**Remedial Investigation Addendum for  
Waste Area Grouping 22, Burial Grounds,  
Solid Waste Management Units 2 and 3,  
at the Paducah Gaseous Diffusion Plant,  
Paducah, Kentucky**

SEPTEMBER 1994  
REVISION 2

# **Response to Comments**

**RESPONSE TO KY DEP AND U.S. EPA COMMENTS**  
**Draft Remedial Investigation Addendum**  
**Waste Area Grouping 22, Burial Grounds**  
**Paducah Gaseous Diffusion Plant, Paducah Kentucky**

**Figure 2-9**  
**LITHOLOGY AND SAMPLING RESULTS**  
**AT WMU 2: C-749 URANIUM BURIAL GROUND**  
**AND WMU 3: C-404 LOW-LEVEL RADIOACTIVE**  
**WASTE BURIAL GROUND**  
 PADUCAH GASEOUS DIFFUSION PLANT  
 PADUCAH, KY.

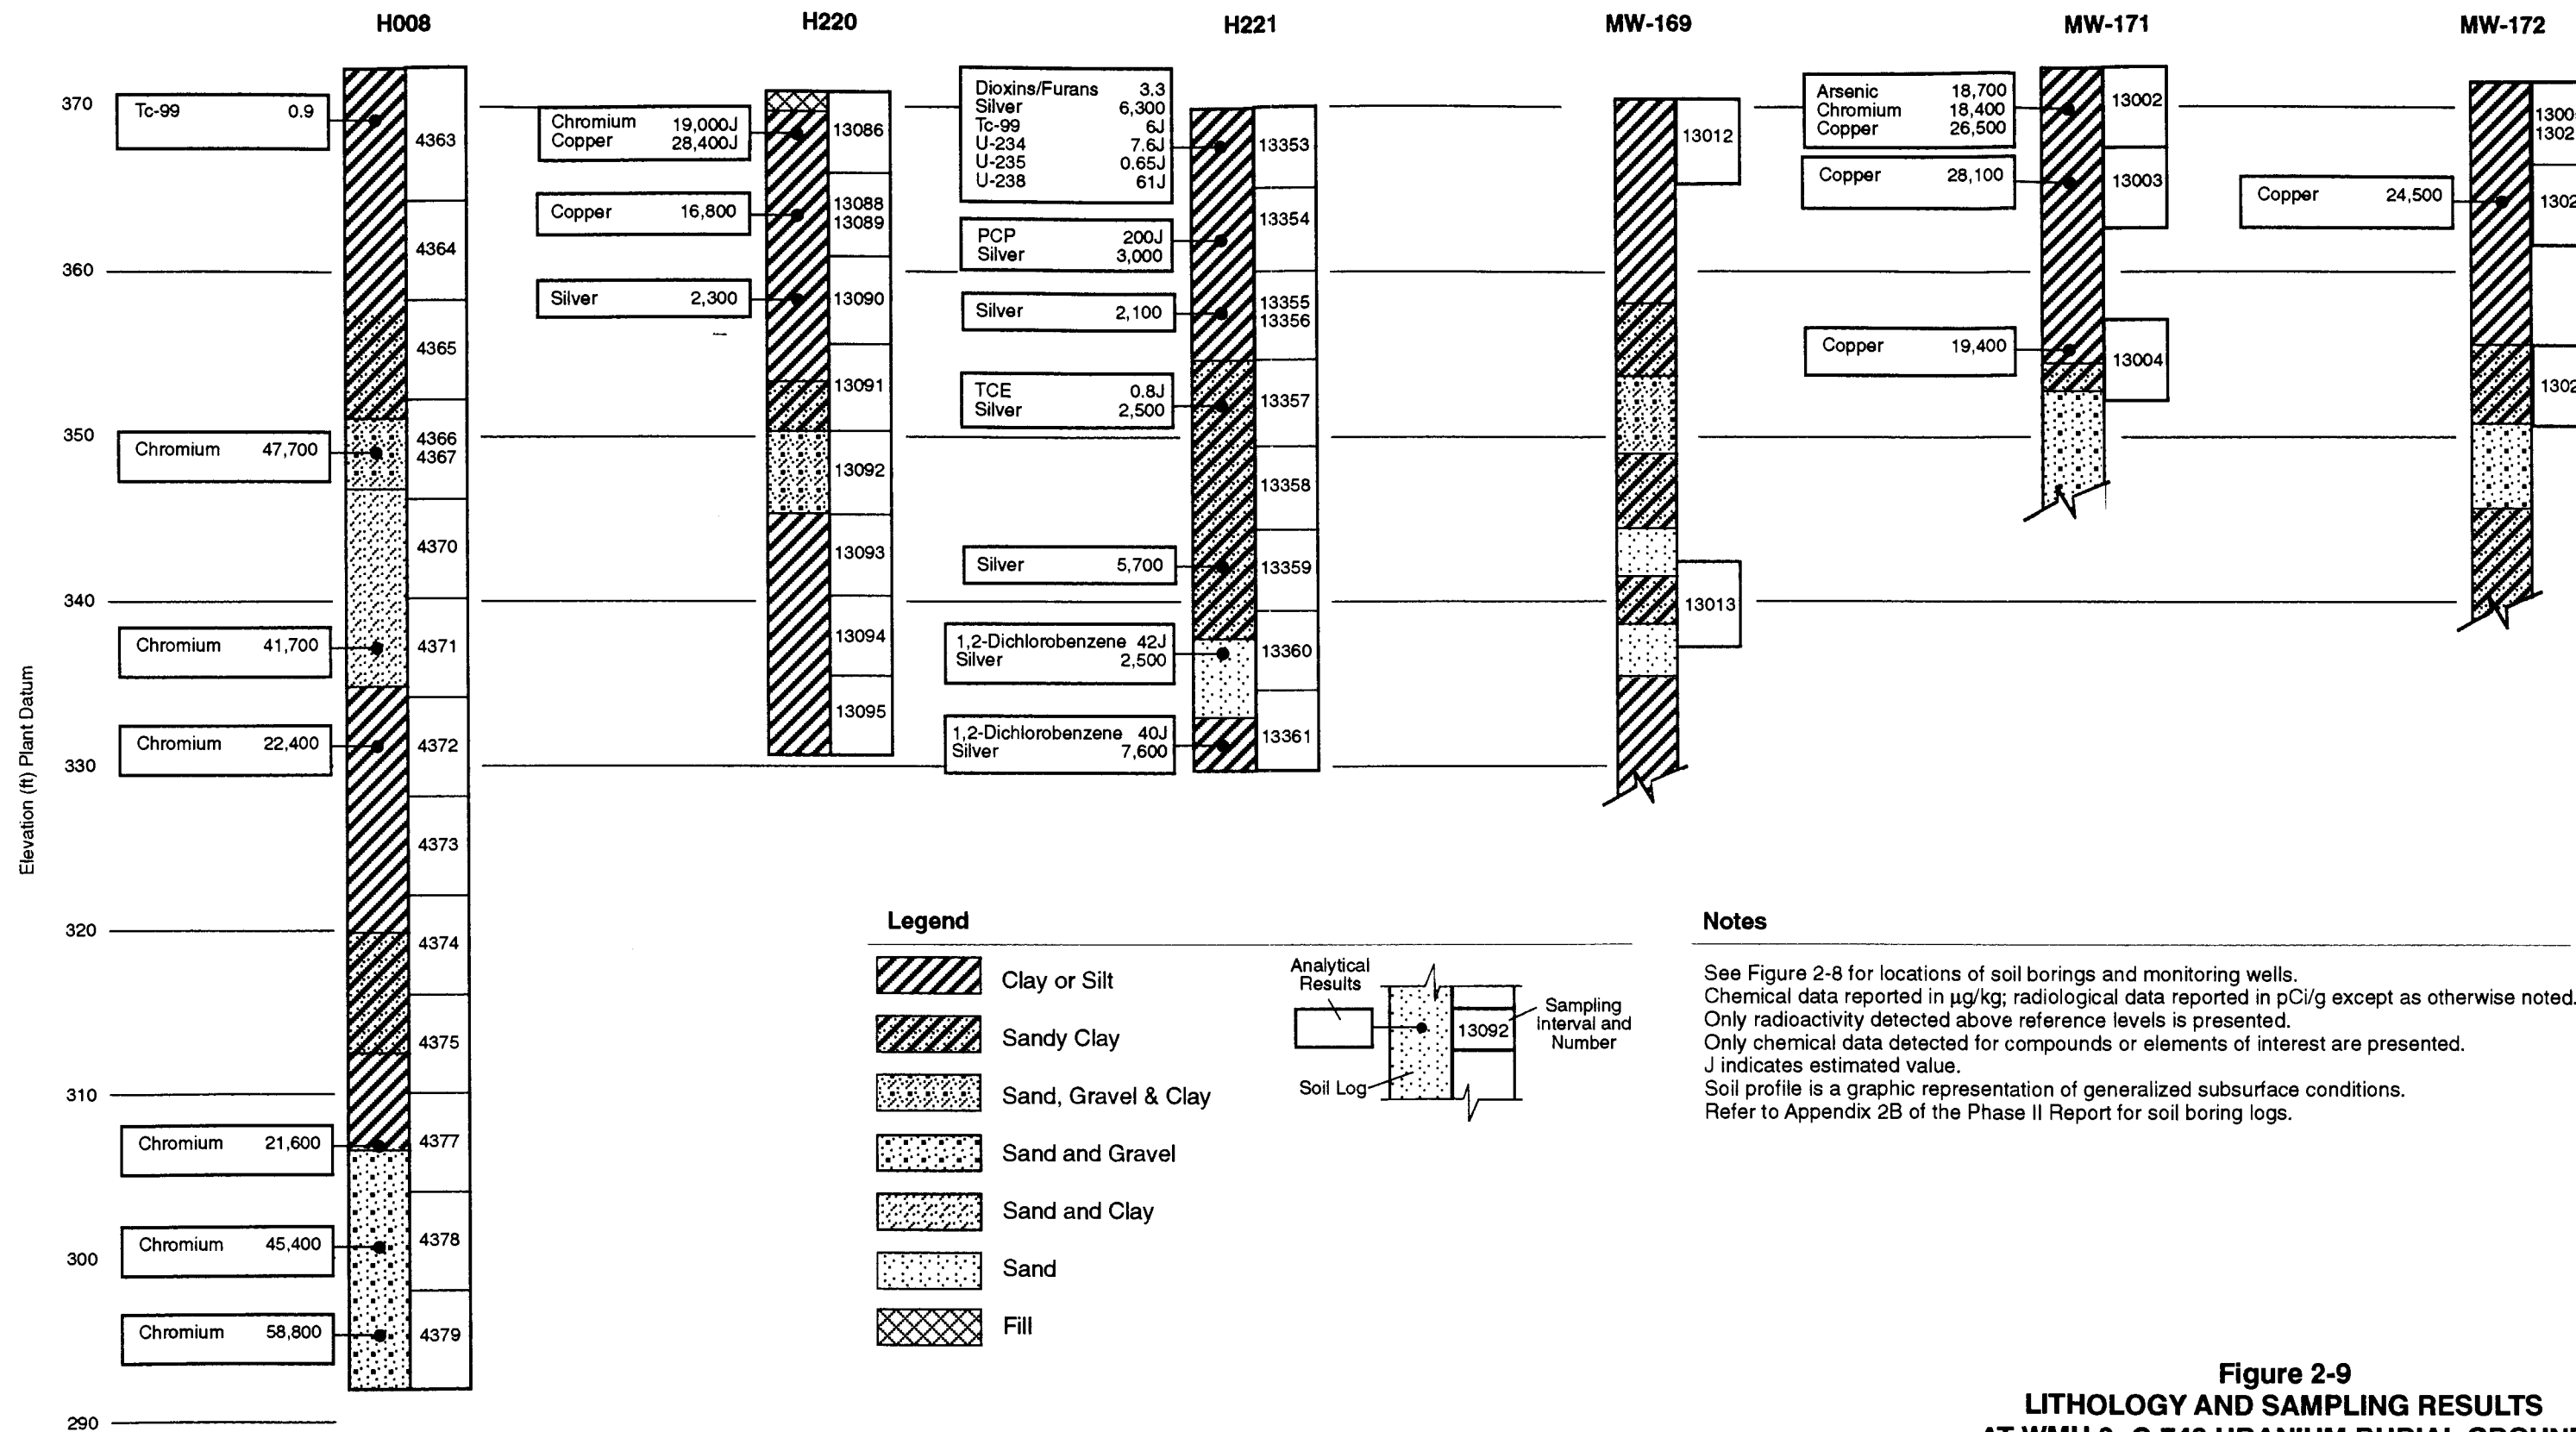
16.	Section 2.4.2 Page 2-26	The last sentence references Figure 2-8 for groundwater rather than Figure 2-9.	Disagree. The reference is for shallow soil analytical results (Figure 2-8) and deep soil analytical results (Figure 2-9).

29.	Section 2.4.2; Page 2-33; Figure 2-9	H-169, MW-171 and -172 are not shown on a site map. MW-171 and 172 are not at SWMU 2 and 3 as the title states. MW-154 is not on table 3B-1. Boring log 170 cannot be found as well as logs for MW-48, -74 and -95. Address these comments by providing the appropriate information.	MW-169, -171, and -172 were added to Figure 2-1. Boring log for MW-170 is the same as for MW-169. Soil lithologies for MW-74 and MW-95 are included in Table 3 B-2 of the Phase II SI. Boring logs for MW-48 and MW-74 are included in Appendix D. MW-154 was drilled to replace MW-58. See MW-58 log for lithology information. H-169 will be changed to MW-169.

**Figure 2-10**  
**RADIATION WALKOVER SURVEY OF DITCH**  
**SOUTH OF WMU 2: C-749 URANIUM BURIAL GROUND**  
**AND WMU 3: C-404 LOW-LEVEL RADIOACTIVE WASTE**  
**BURIAL GROUND**

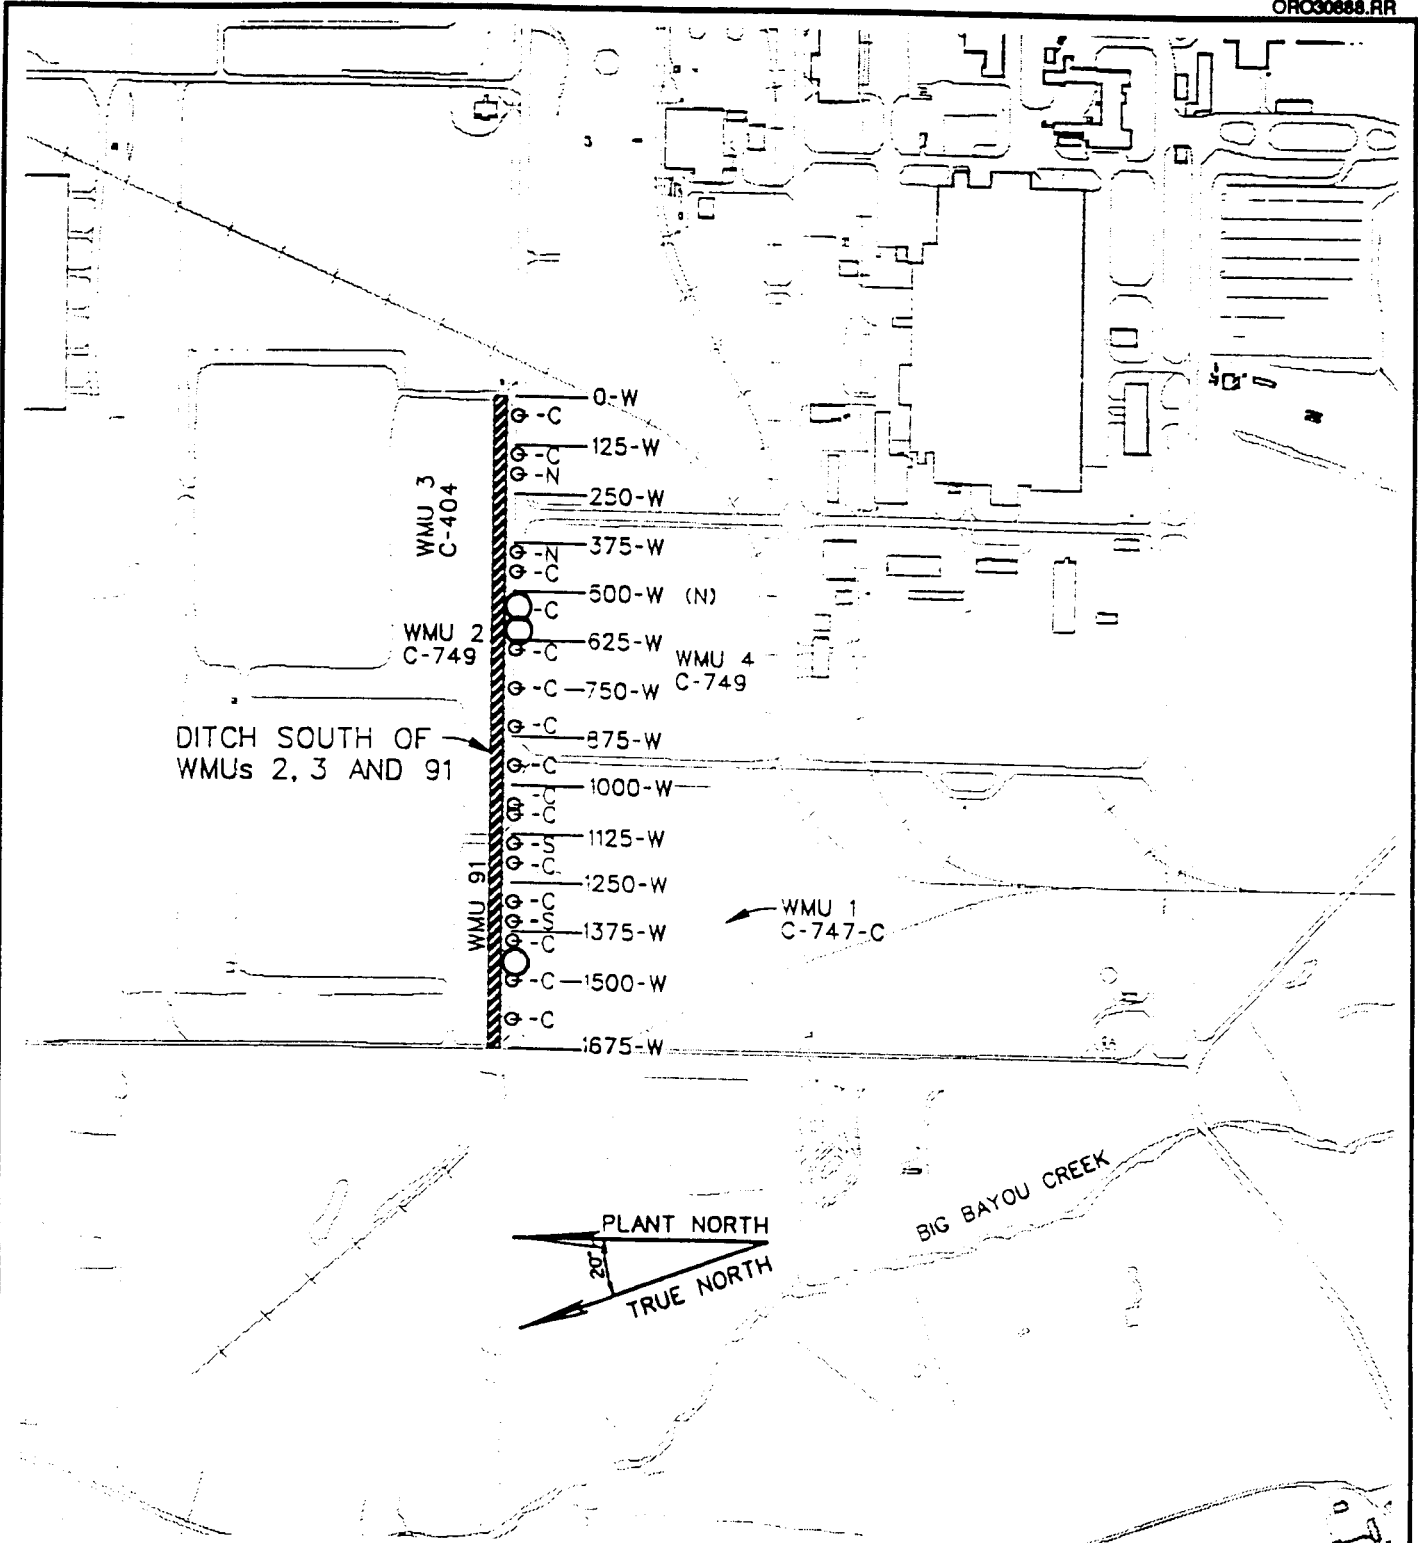
Comment Number	Section/ Page	Comment	Response
34.	Section 2.4.2.1; Page 2-35; Figure 2-10	Provide a north arrow and a scale on the figure.	Agree. North arrow will be added to Figure 2-10.

**Figure 2-11**  
**TRENDS OF TCE AND Tc-99 IN MW-88**  
**PADUCAH GASEOUS DIFFUSION PLANT**  
**PADUCAH, KY.**

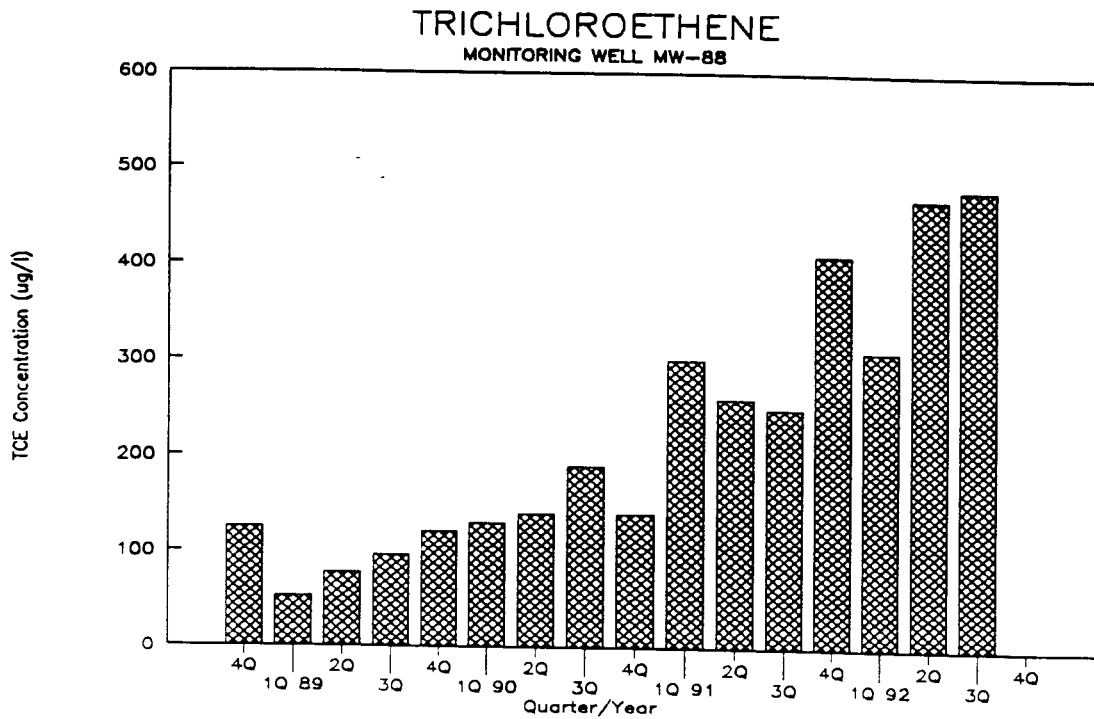
Comment Number	Section/ Page	Comment	Response
27.	Page 2-46 Figure 2-11	This figure showing trends of TCE and Tc-99 in a particular well is very informative/helpful in seeing the contamination over time.	Agree.
